## Response to Questions from the AQCC

### Spatial Distribution of 2007 Cntl4 RRF (ENVIRON, Dec '03)

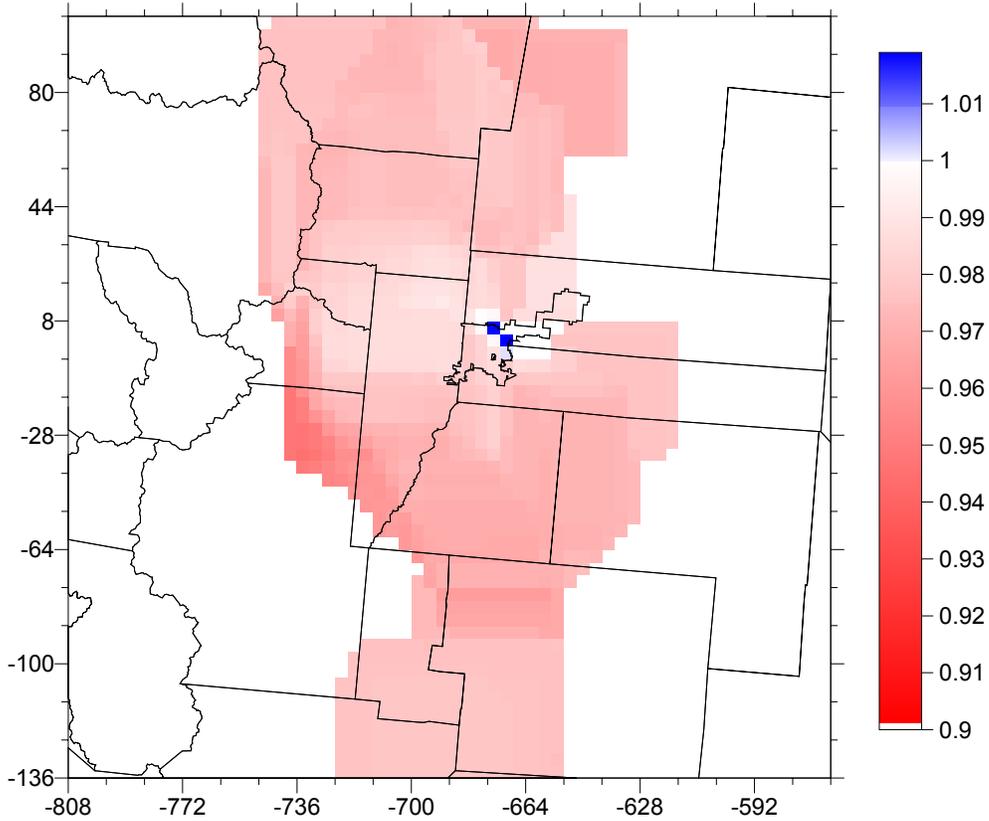
**8. Why is the Relative Reduction Factor at the Rocky Flats north monitor so much higher than the RRF's at the other monitors? Please spatially plot the RRF's over the modeling domain and present with the prehearing statement of the Division.**

**ANSWER:** Table 8-1 presents Relative Reduction Factors (RRF) that was developed for the 2007 base and the 2007-attainment scenario. As seen in Table 8-1, the RRFs from Rocky Flats are in-line, and in some cases, lower than the rest of the monitors for both the base 2007 case and the 2007 attainment scenario.

Figure 8-1 presents a spatial plot of the RRFs over the modeling domain. This graphic was produced for the 2007 base case+flash+rice+8.1rvp/40%EtoH scenario in December 2003. Although the relative reduction factors have been updated since then, the general spatial pattern of RRFs can be seen. As shown in Figure 8-1, the RRFs in the northern Denver metro area are generally closer to 1.00 (stiffer) than in other areas.

- Clear/white area RRFs not calculated because ozone always < 70 ppb
- RRFs > 1.0 in downtown Denver due to NO<sub>x</sub> reductions
- RRFs “stiffer” west of DMA (e.g., Rocky Flats)

Figure 13-1: Source regions for the OSAT analysis

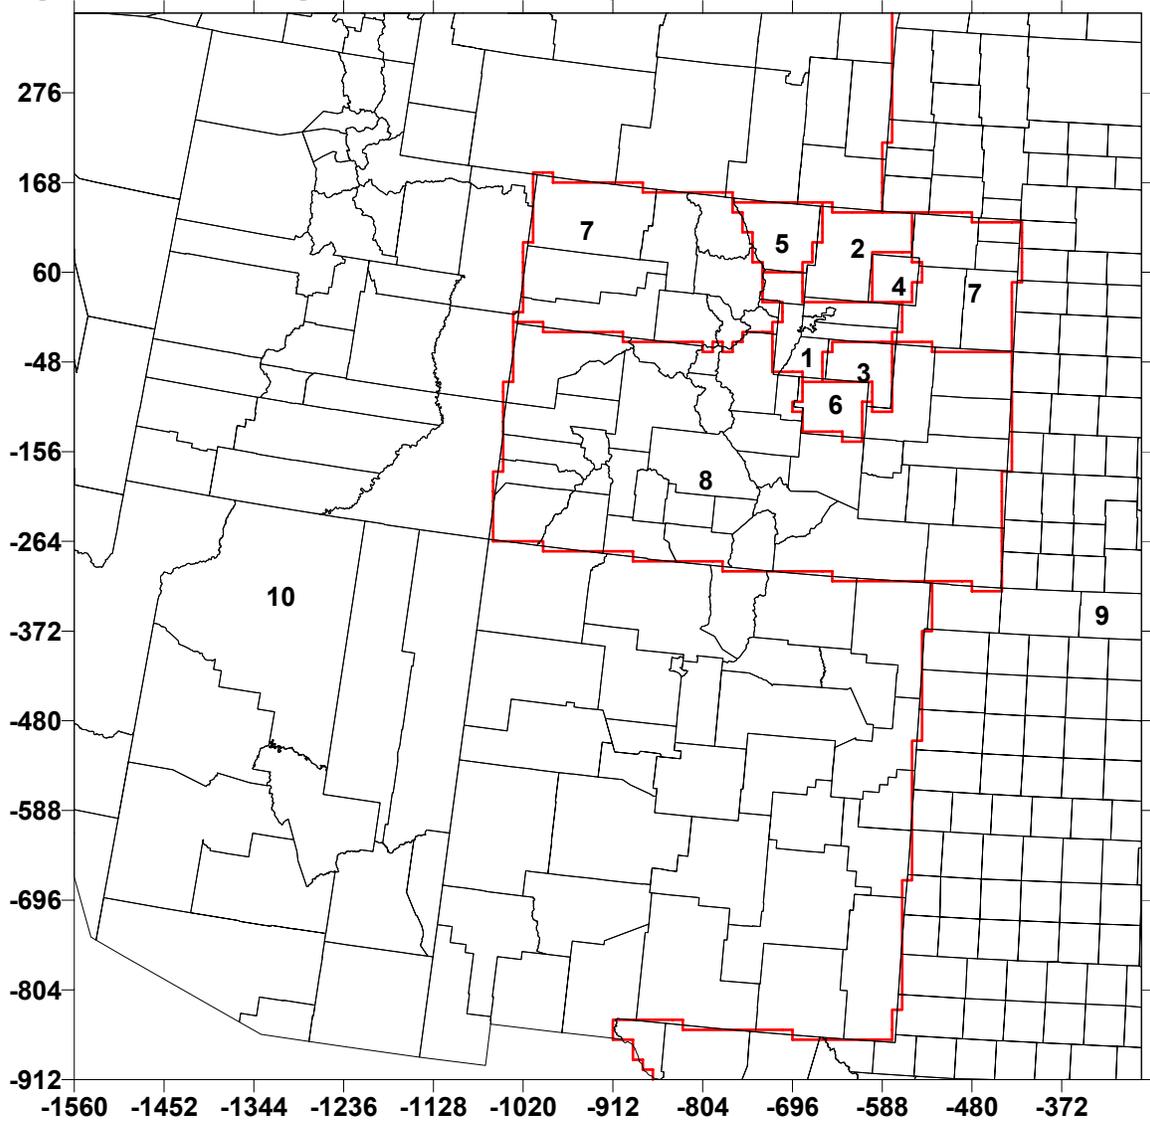
- 13. Discuss the amount of ozone transported into the Denver area and transported into the state. Please identify how the modeling accounts for this amount of ozone transported into the area, how that value is arrived at and why it is valid?**

**ANSWER:** An Ozone Source Apportionment (OSA) by ENVIRON is underway. It is anticipated that the (OSA) will be able to determine the amount of ozone transported into the Denver area from other areas of the state and from outside of the state. Figure 13-1 presents the ten source regions that have been set up as part of the OSA analysis.
